**ADDENDUM NO. [1]**

**Date: September 13, 2019**

**RE: SCHOOL DISTRICT OF LA CROSSE  
7 RIVERS CHARTER SCHOOL  
225 5<sup>TH</sup> AVE SOUTH  
LA CROSSE, WI 54601  
HSR 19003**

## 1 FIRST FLOOR REMODEL PLAN

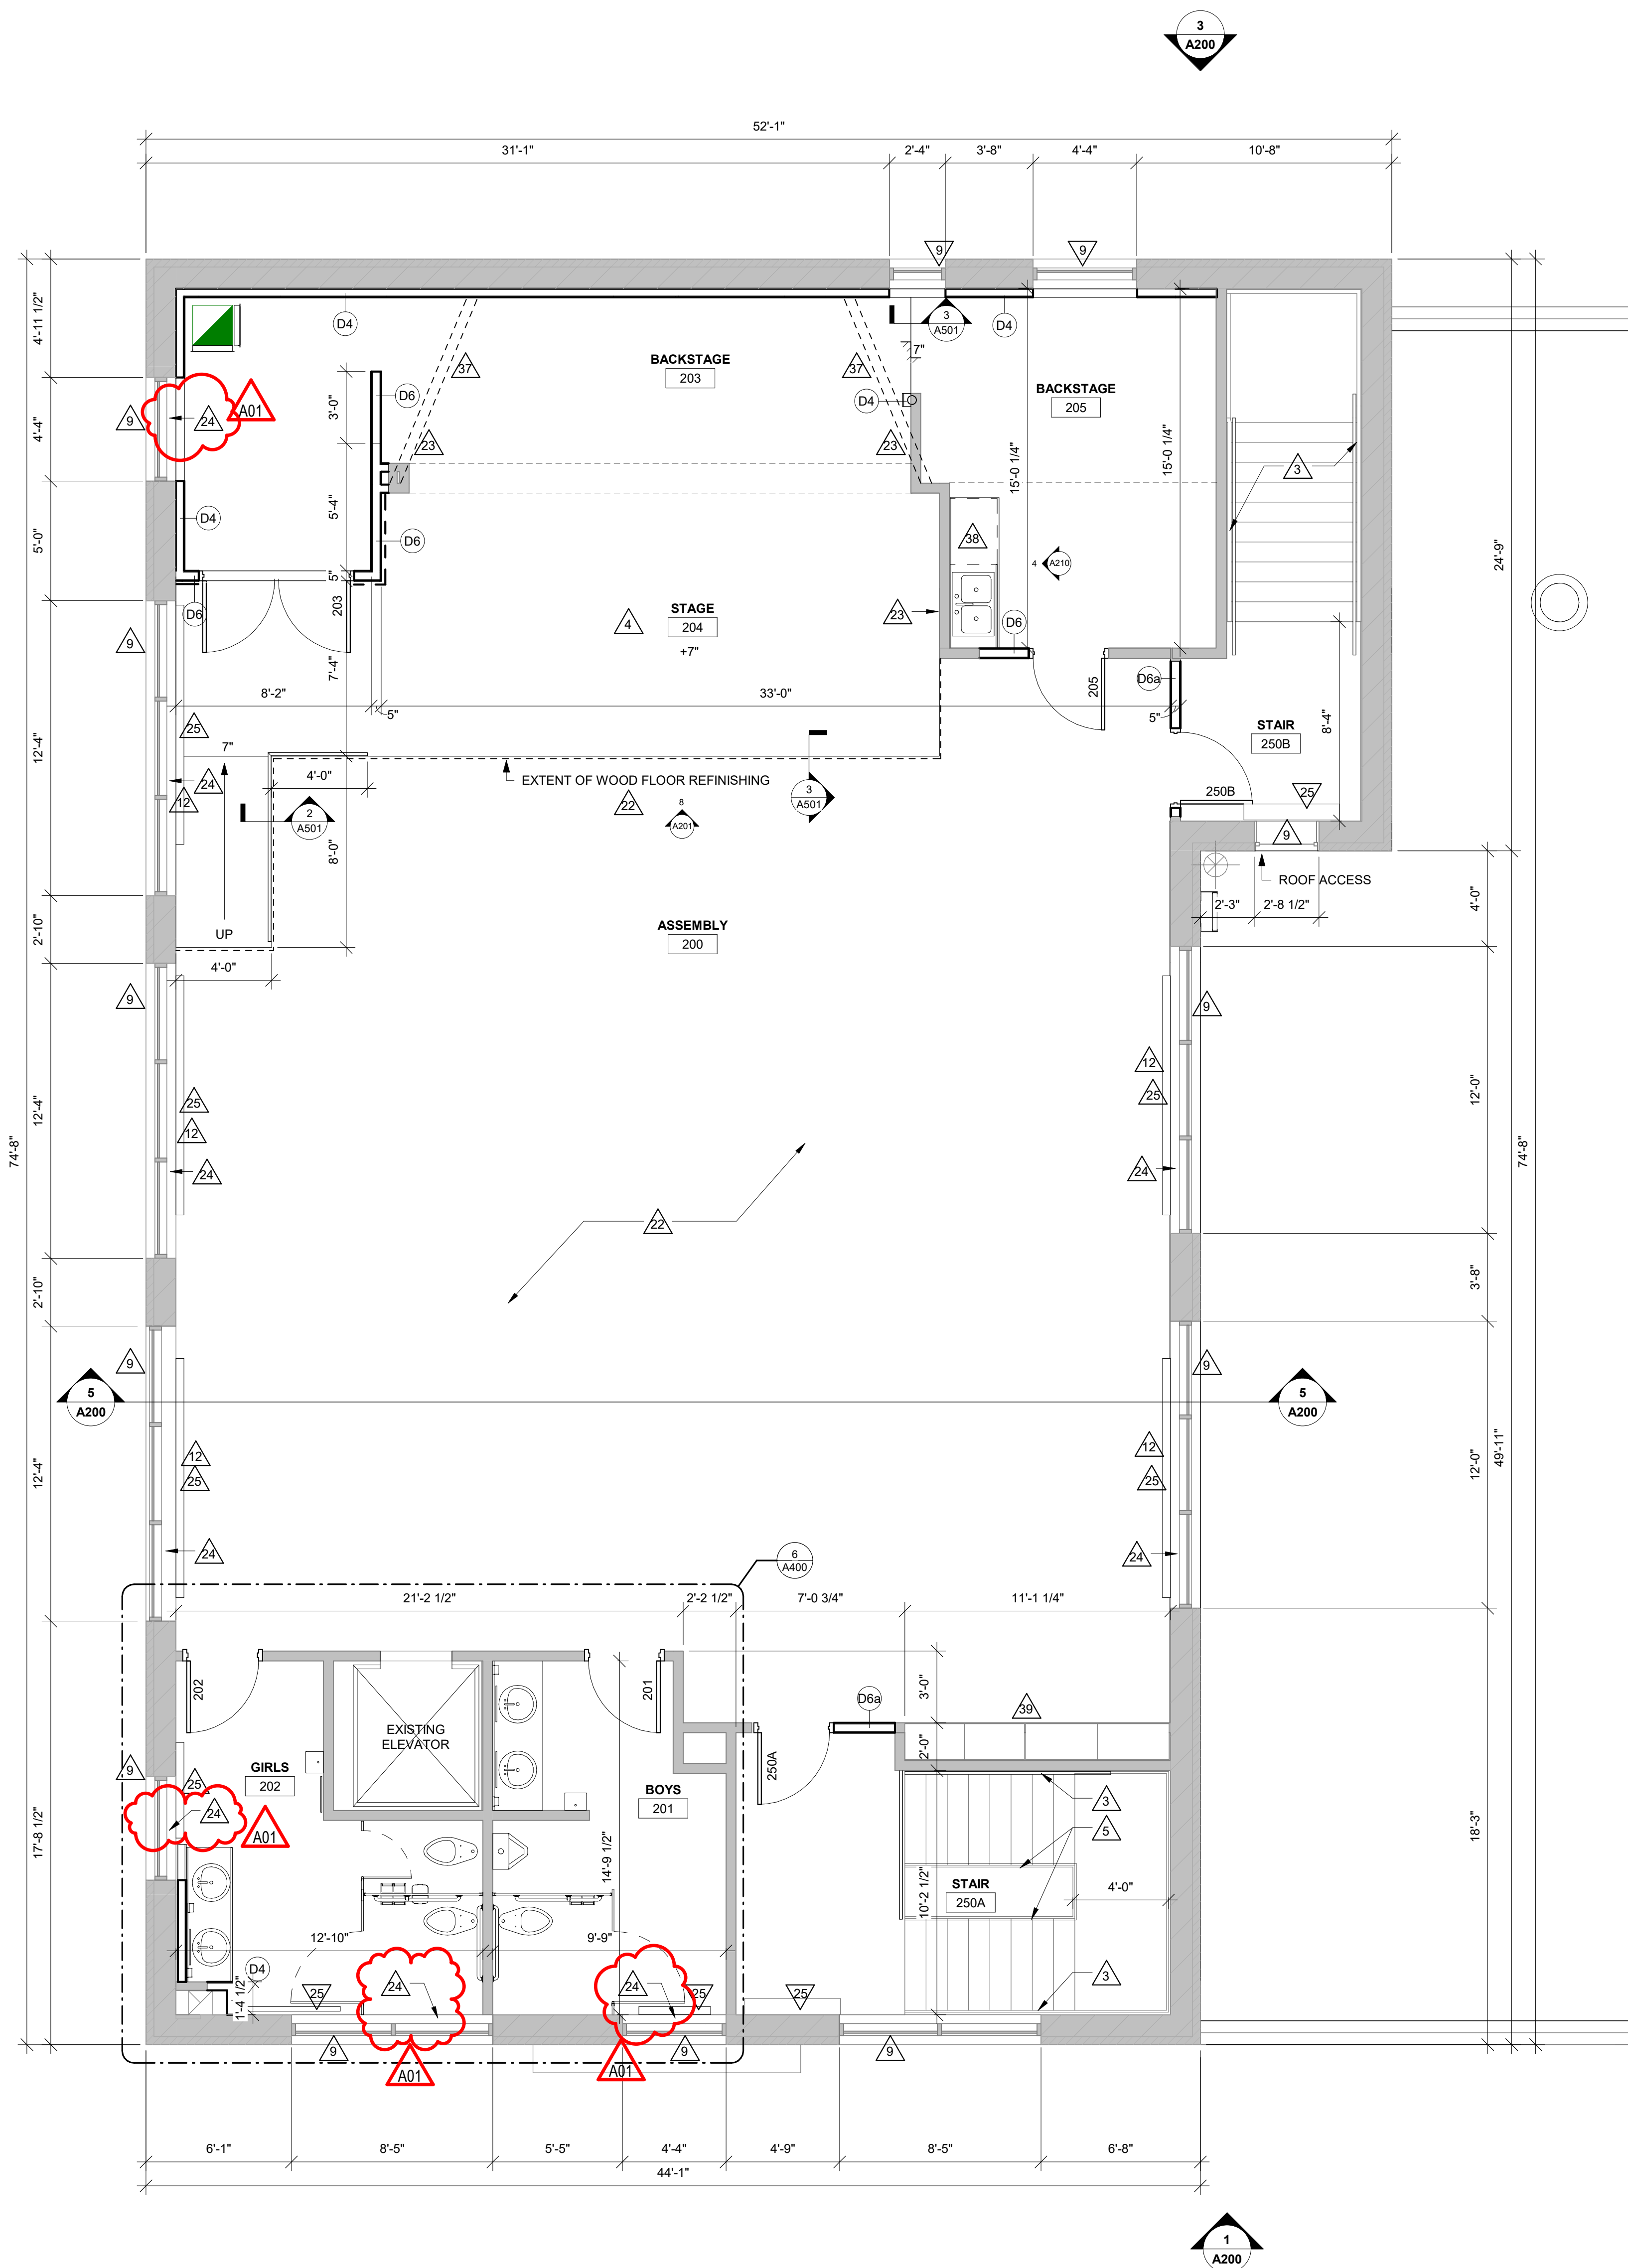
21. Sheet A101 FIRST FLOOR REMODEL PLAN 30 x 42 attached hereto

- a. Revisions clouded on Drawing.
- b. Removed 2 windows from west wall that are part of Alternate Bids 3 and 4.
- c. Added furring to south wall – wall type A1.

## BASEMENT REFLECTED CEILING PLAN

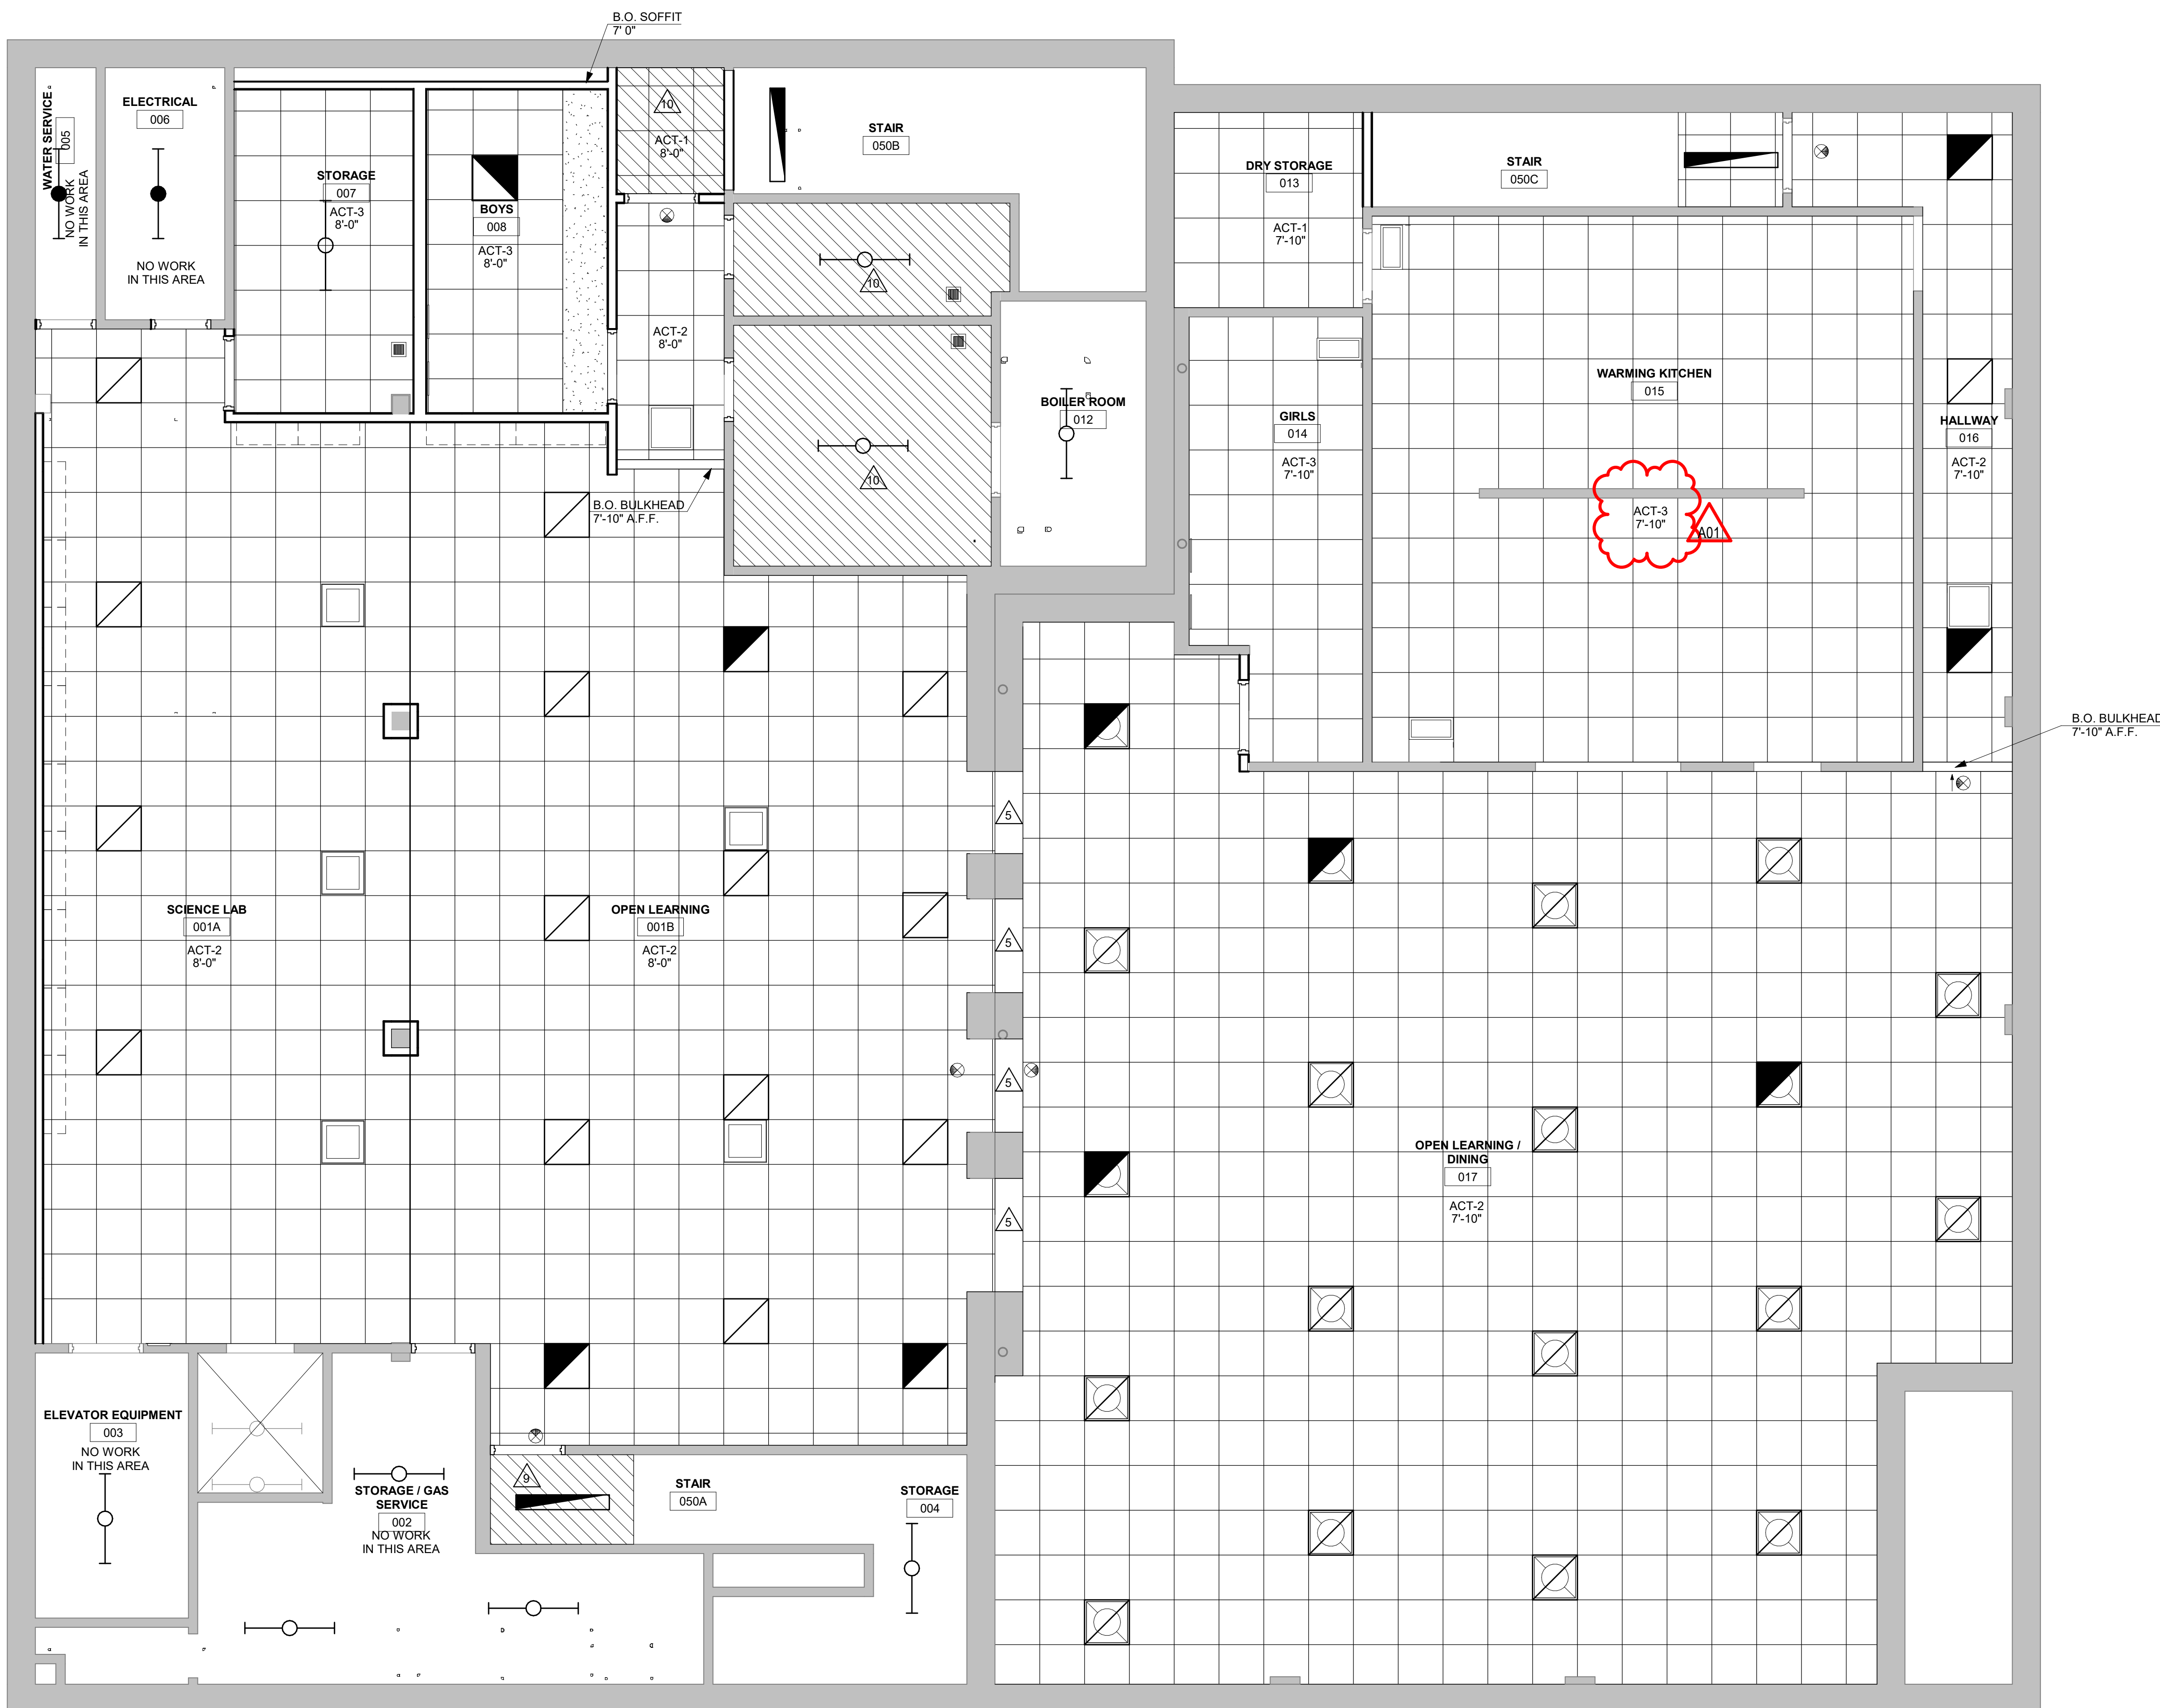
23. Sheet A110 BASEMENT REFLECTED CEILING PLAN 30 x 42 attached hereto

- a. Revisions clouded on Drawing.
- b. Include new ceiling in Warming Kitchen 015
